FAP 649 ROUTE (IL 17)
SECTION (2,3) RS-5
PROJECT STP-KDBY(767)
DESIGNED OVERLAY
MARSHALL COUNTY

CONTRACT NO. 68J95

USER NAME = Kevin.Sills	DESIGNED -	REVISED ADDENDUM 4/13/2026
	DRAWN -	REVISED -
	CHECKED -	REVISED -
PLOT DATE = 1/19/2026	DATE - \$DATESUBMIT\$	REVISED -

CULVERT REPAIR SLAB DETAILS
ILLINOIS ROUTE 17 OVER SHAW CREEK
SN 062-2003

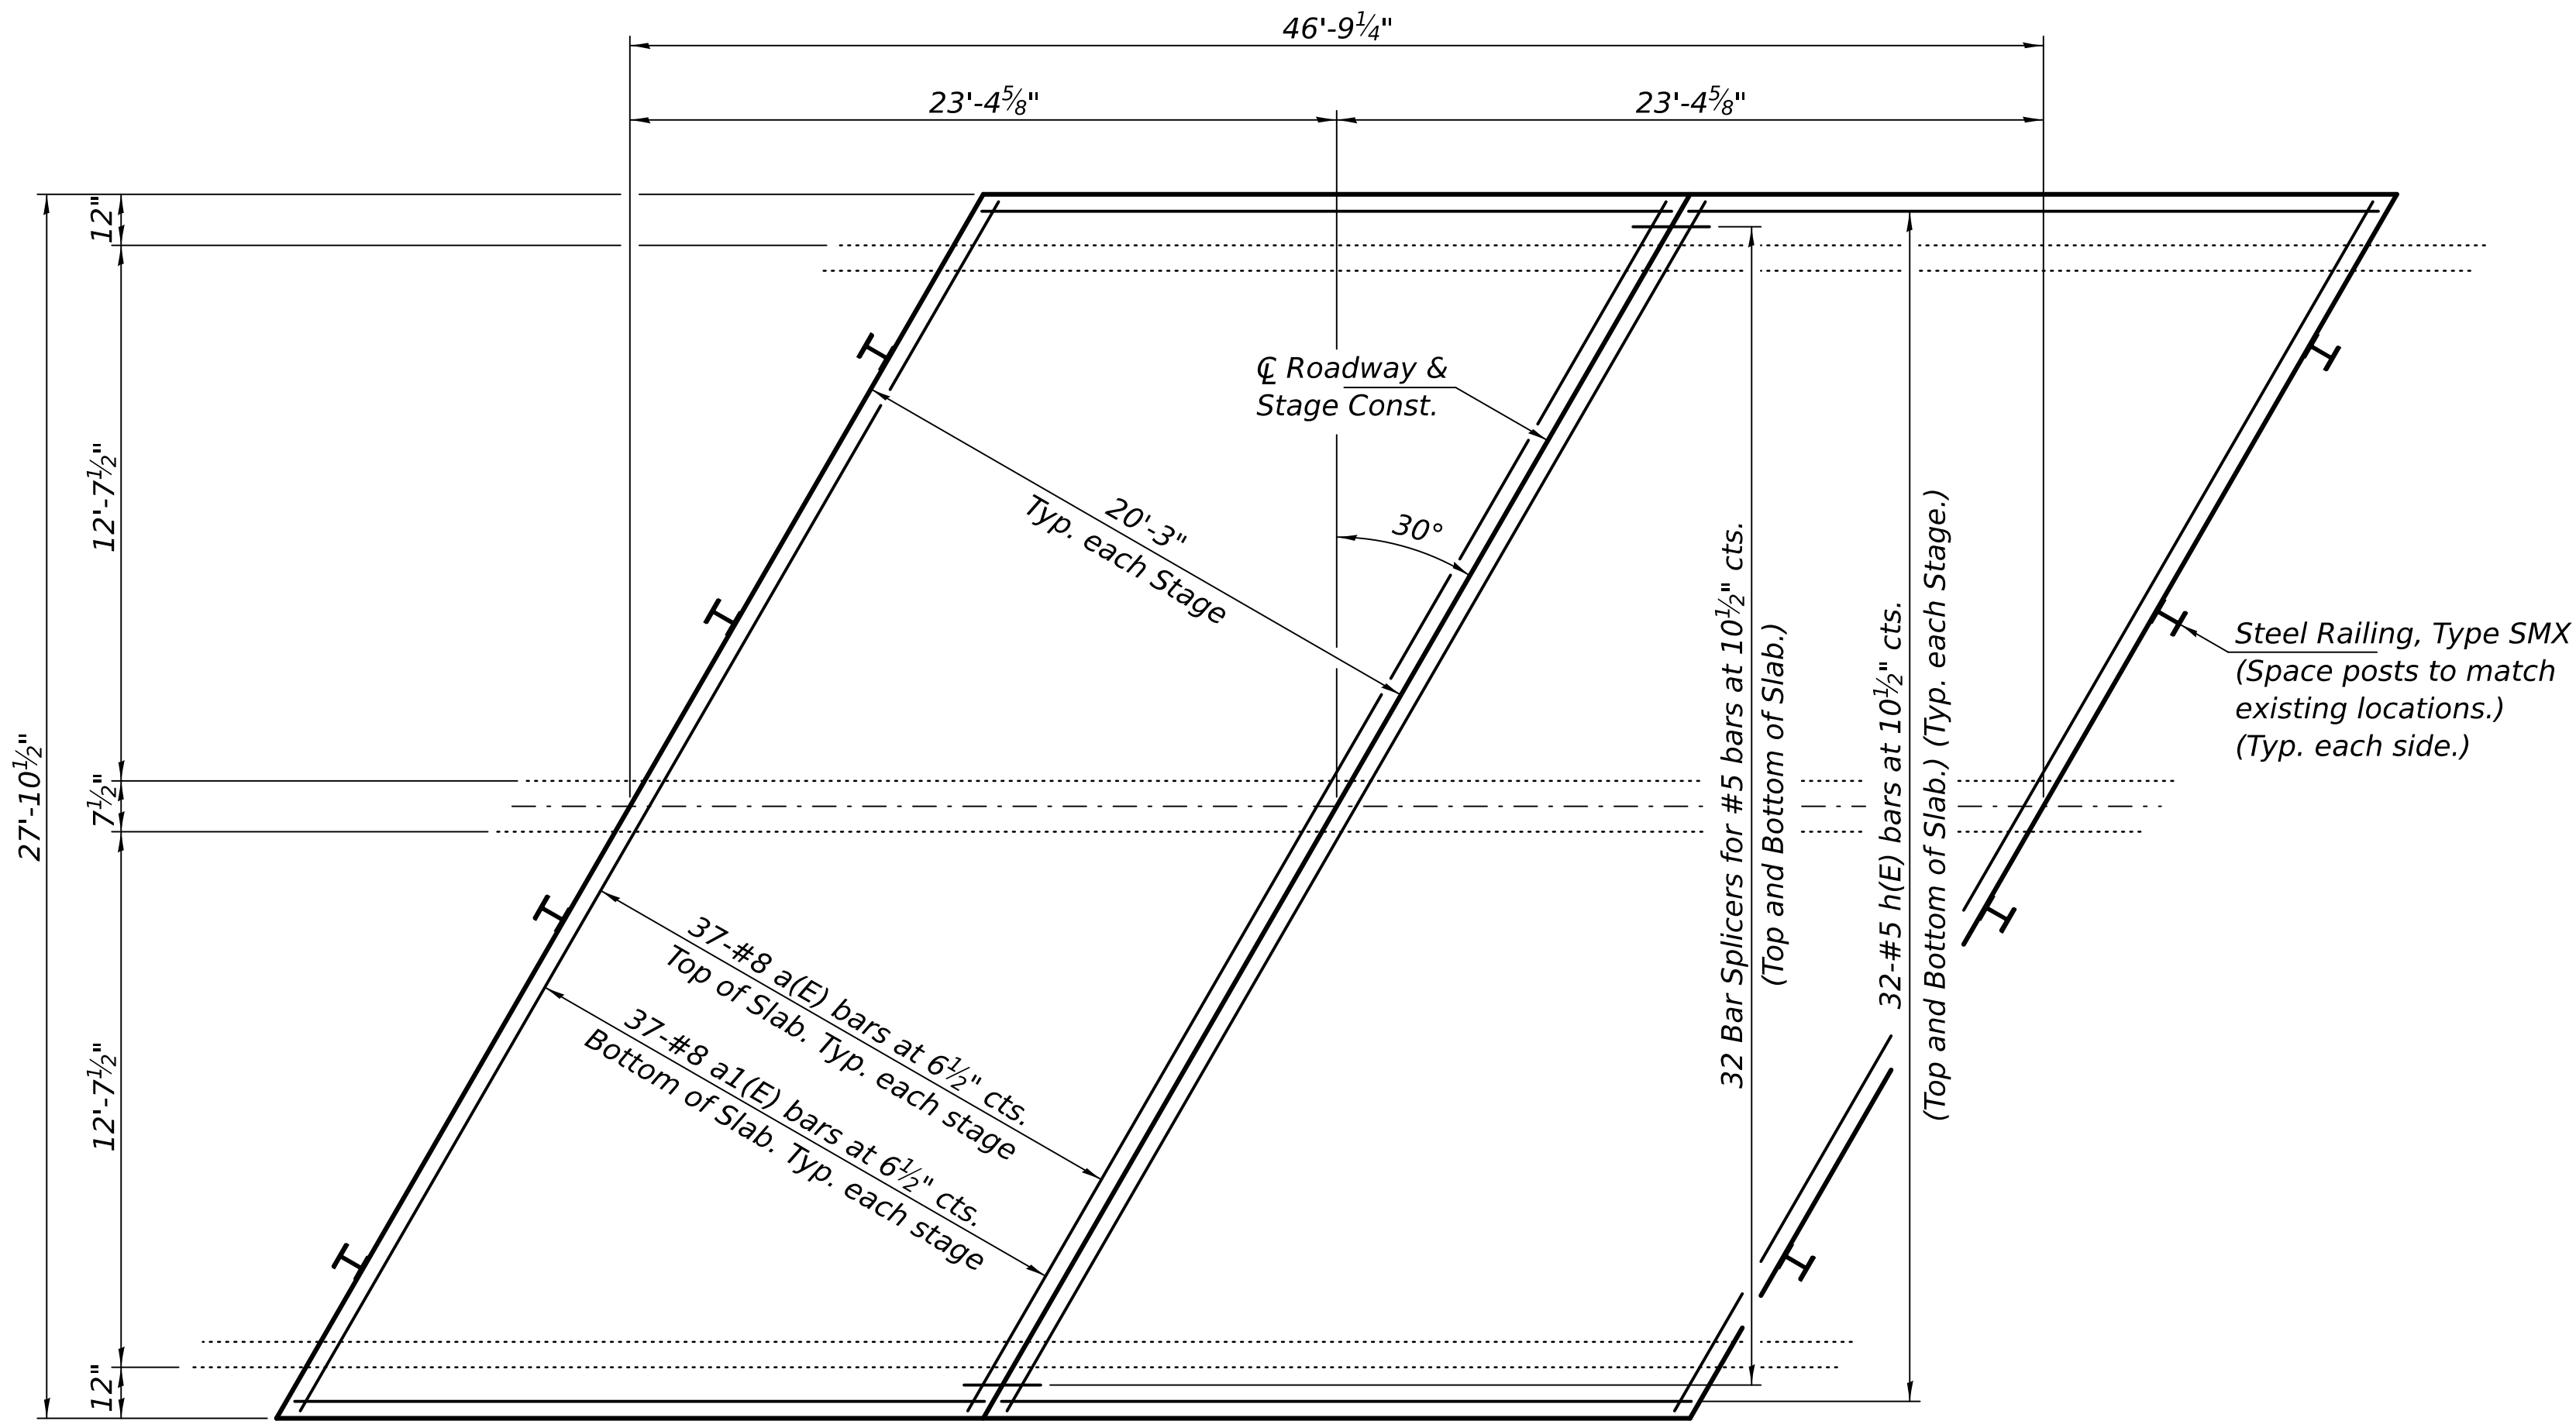
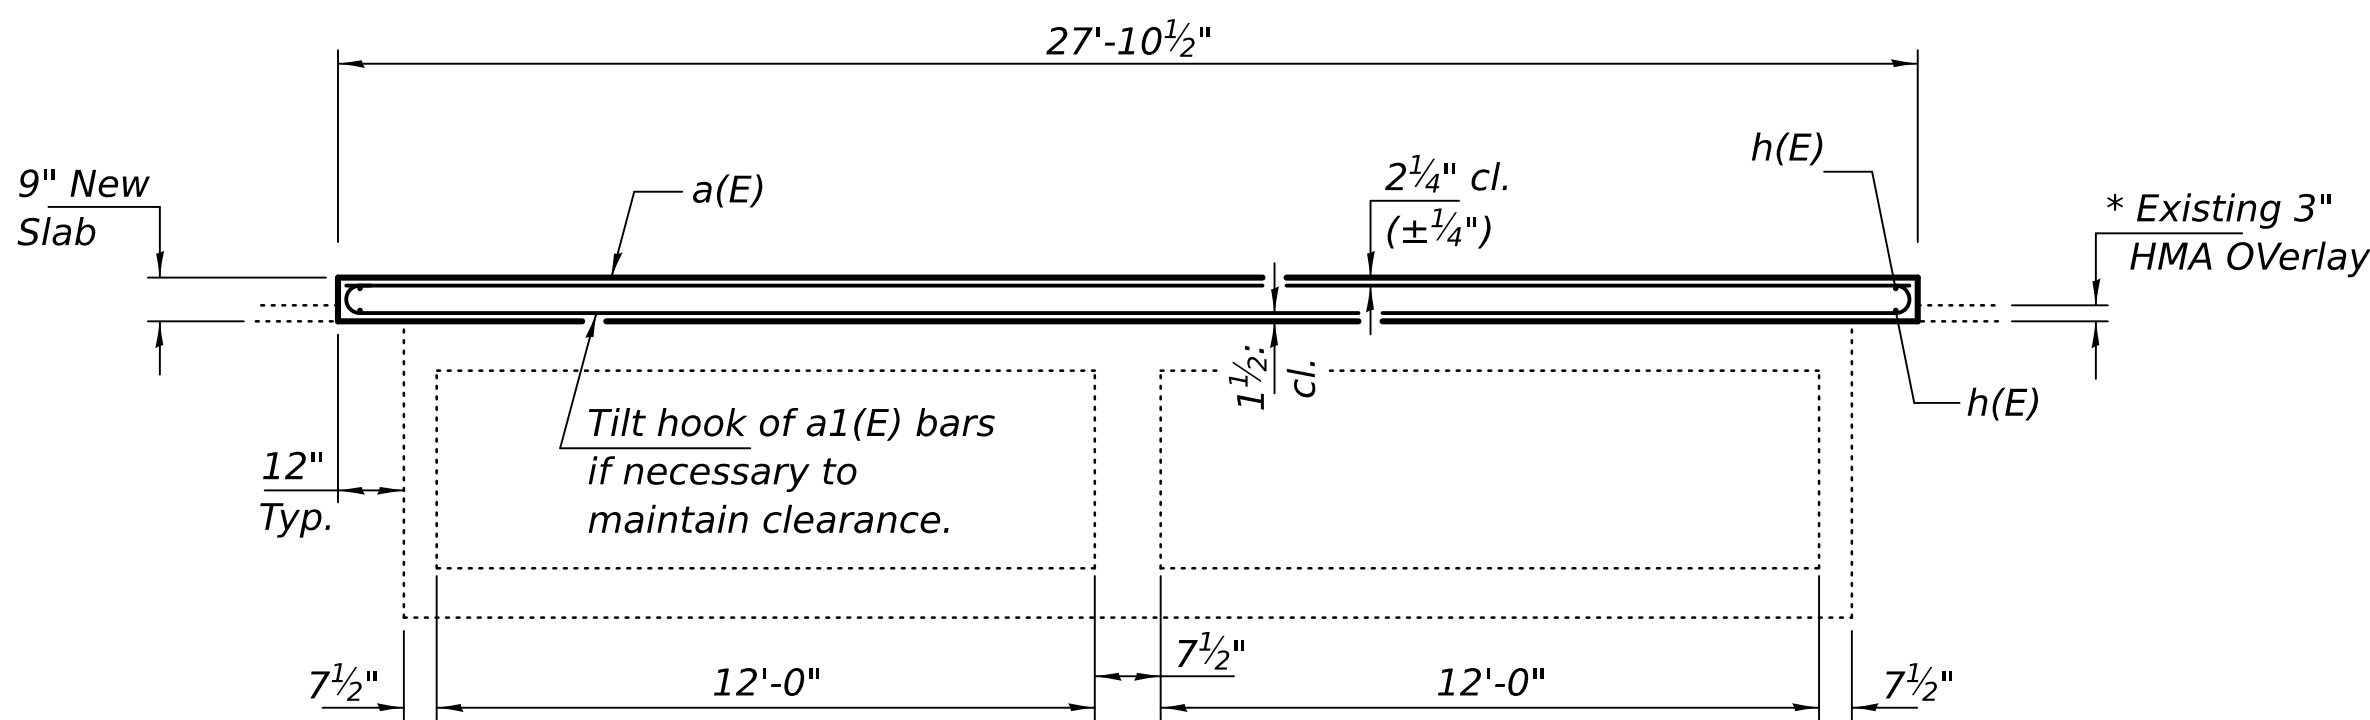
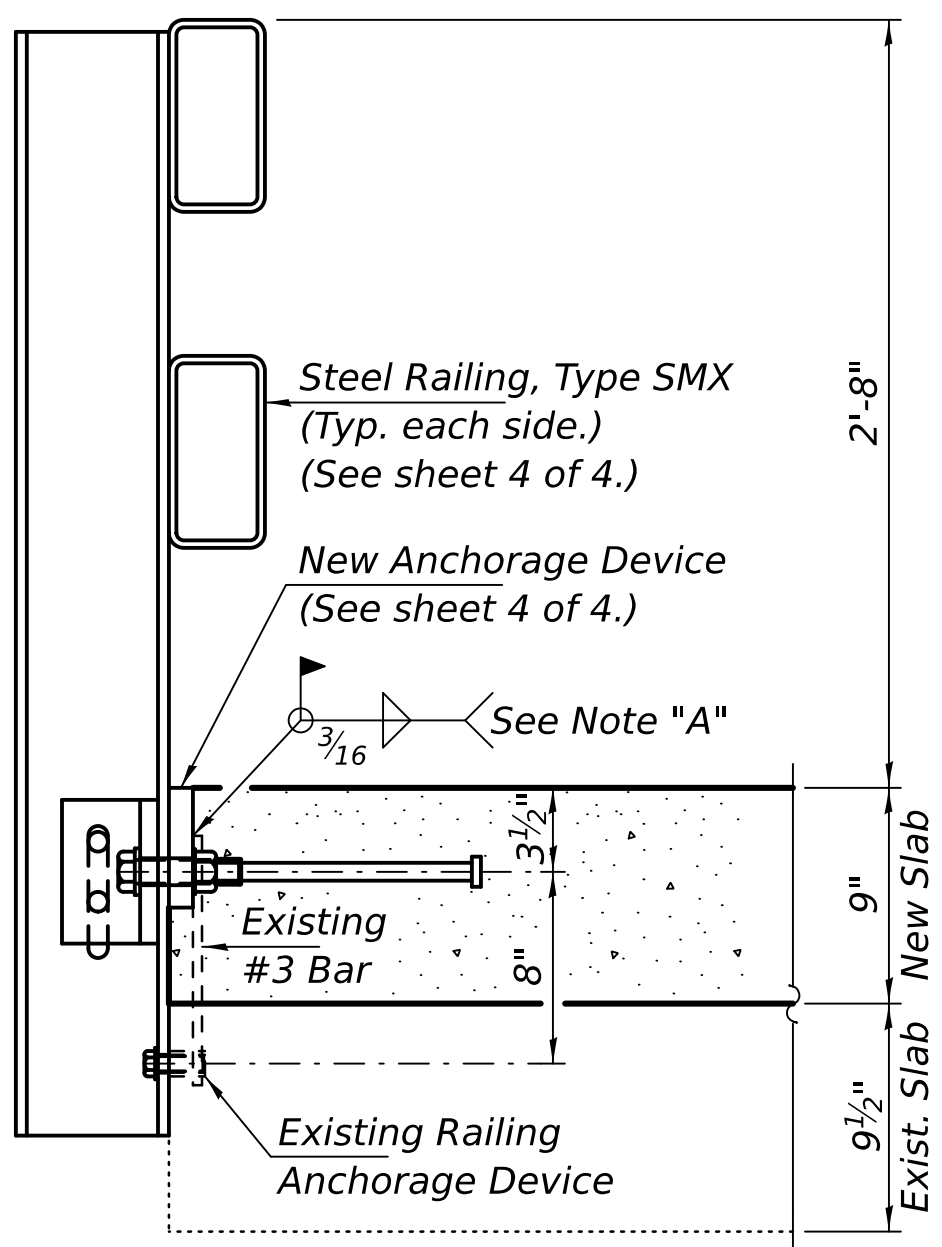
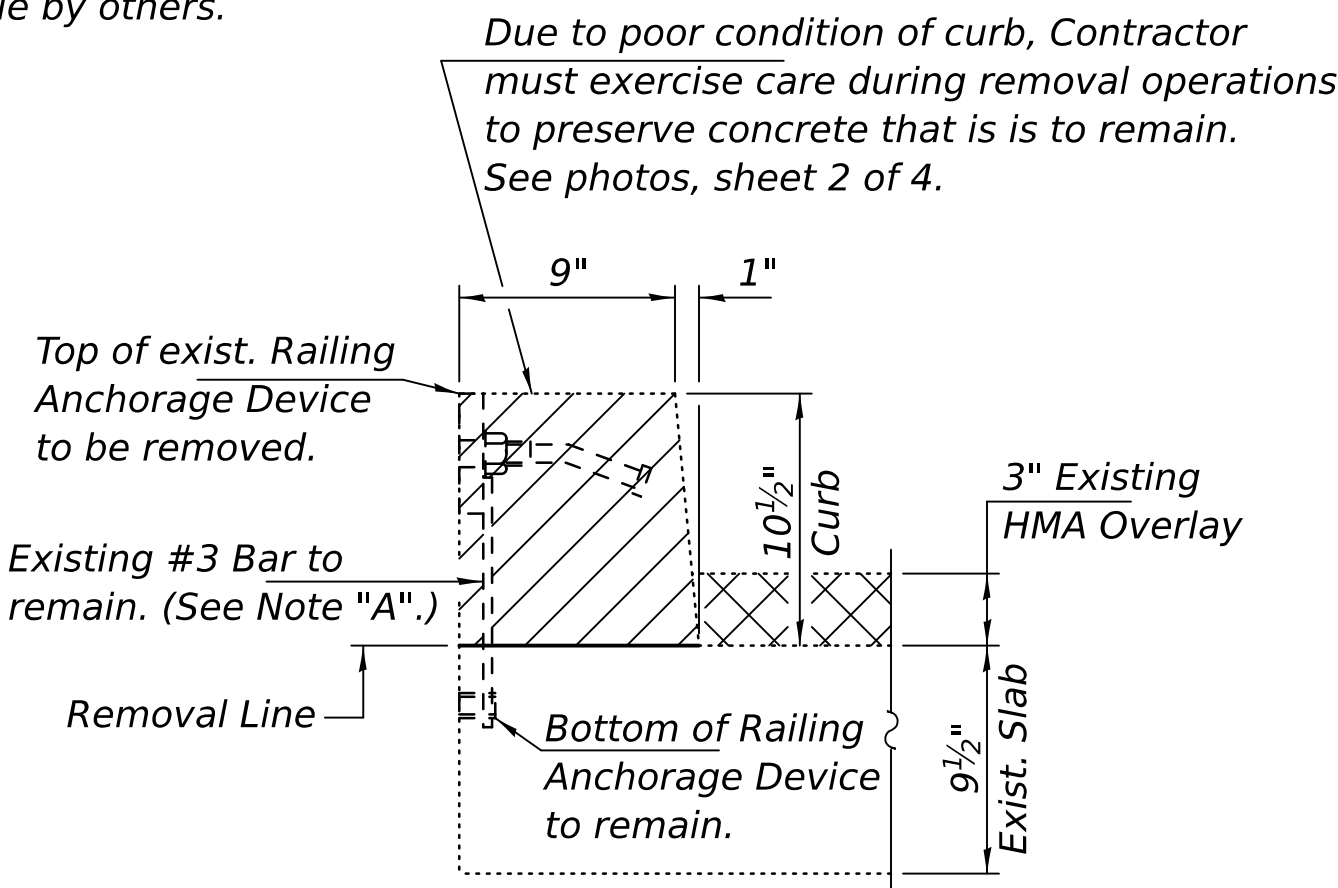
* Remove existing 3" HMA overlay and replace with new 9" concrete slab as shown. Transition to match roadway profile by others.
